Response to RFI No. One

Project: **Tampa Palms Clubhouse Meeting Facility**
16101 Compton Drive
Tampa, Florida 33647

Ha. Project No. 13017

C1260-4

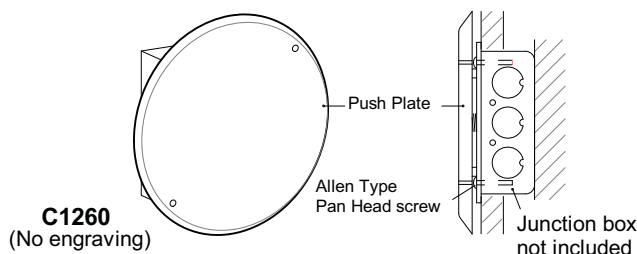
1. Do you have a spec for the automatic door opener required for this door? Do you want operators on both doors?

Response: Yes, provide opener for both leafs of the double door. Please see the attached information on a Horton Automatic Door Opener, Easy Access Series 7100/Surface Applied with Horton Push Plates, C1260-4 (Engraved).
